Access Compliance Report Public Rights-of-Way (Curb Ramps)

Main Street: NEWKIRK_RD Cross Street: WELDON_HEIGHTS Location: SE

ADA ID: RPAT211104132535 Ramp Type: Type 4 - Parallel Initial Pass/Fail: Fail Overall Compliance: No Severity Score: 32

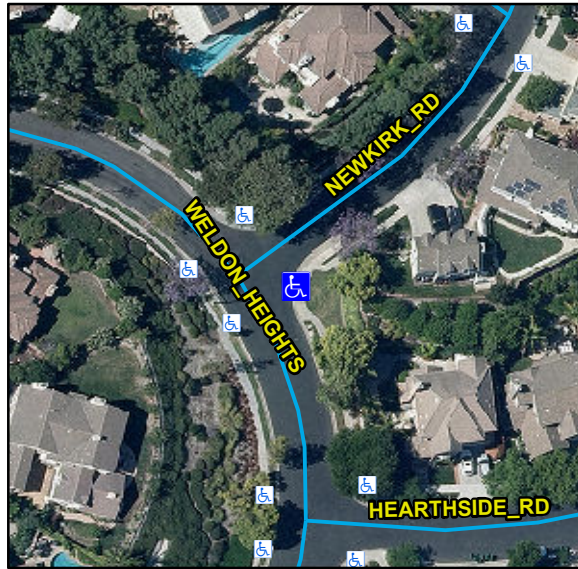
Compliance	Description	Data	Compliance	Description	Data
N/A	Ramp Length LT (in)	83	N/A	Ramp Length RT (in)	86
Yes	Ramp Width LT (in)	53	Yes	Ramp Width RT (in)	54
No	Ramp Run Slope LT (%)	16	Yes	Ramp Run Slope RT (%)	1.3
No	Ramp Cross Slope LT (%)	2.6	No	Ramp Cross Slope RT (%)	2.3
N/A	Landing Present	N/A	N/A	DWS Provided	N/A
N/A	Landing Length (in)	N/A	N/A	DWS Contrast	N/A
N/A	Landing Width (in)	N/A	N/A	DWS Length (in)	N/A
N/A	Landing Run Slope (%)	N/A	N/A	DWS Full Width	N/A
N/A	Landing Cross Slope (%)	N/A		DWS Offset Type	N/A
N/A	Landing Movement Obstructed?	N/A	N/A	DWS Offset Left (in)	N/A
	Landing Movement Type	N/A	N/A	DWS Offset Right (in)	N/A
N/A	Landing Shared	N/A			
N/A	Clear Space	Yes			
N/A	Clear Space To Crosswalk (in)	N/A			
N/A	Marked Crosswalk 1	No	N/A	Marked Crosswalk 2	No
	Crossing 1 Direction	N		Crossing 2 Direction	W
	Marked Crosswalk 1 Width (in)	N/A		Marked Crosswalk 2 Width (in)	N/A
N/A	Ramp Inside Crosswalk 1	N/A	N/A	Ramp Inside Crosswalk 2	N/A

Remove & Replace Curb Ramp With Two New Directional Ramps or Equivalent.
